ZTE CORPORATION**Product Change Description**

[Z791G]
[ZTE Corporation]

[Z791]
[ZTE Corporation]

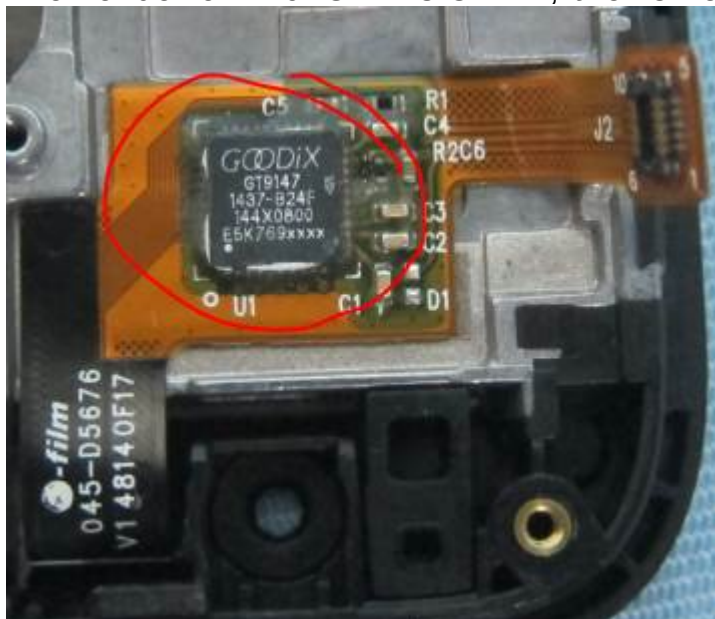
Other changes: Yes

The SIM card socket is changed from push-push type to push-pull type

The earphone jack is changed from 13.1X6.6X4.55mm to 8.7*12.66*4.2mm

The Diversity ANT change
From Z791:

To Z791G
